Technical change HDC base housings size 16D/32A/32B

PCN-number: PKDPB72-20181116-00-A

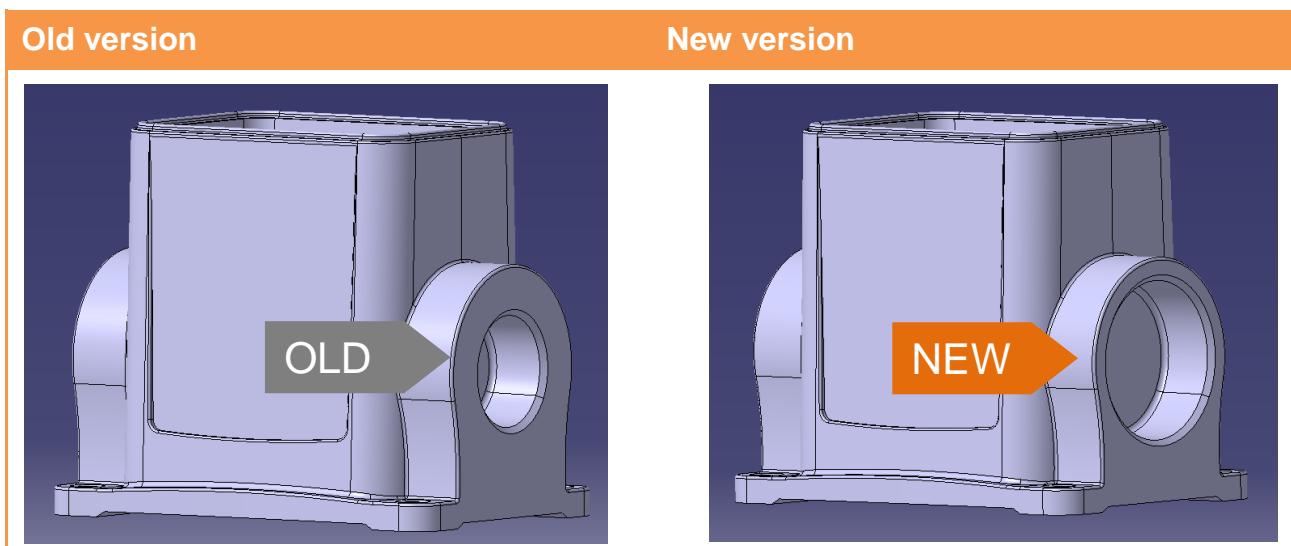
The base housings are generally prepared for two drillings or cable entries. For base housings with only one cable entry, the opposite hole is closed.

The inner diameter of the hole preparation is now significantly enlarged. However, this has no further consequences for the user or customer.
